# INFORMATION NOTE

N° 024/16

## Reduced pocket size in the carrier tape of package PG-ATSLP-12

**Subject of Change:** Carrier tape pocket size decreased

### Description of Change:

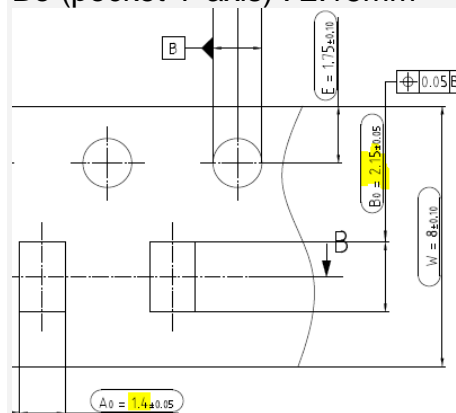
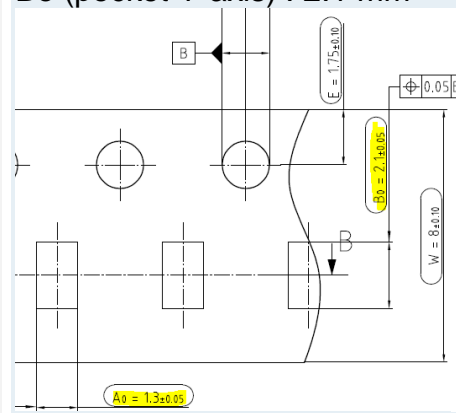
Ao (pocket X-axis) : 1.4 mm  
Bo (pocket Y-axis) : 2.15mm

Ao (pocket X-axis) : 1.3 mm  
Bo (pocket Y-axis) : 2.1 mm
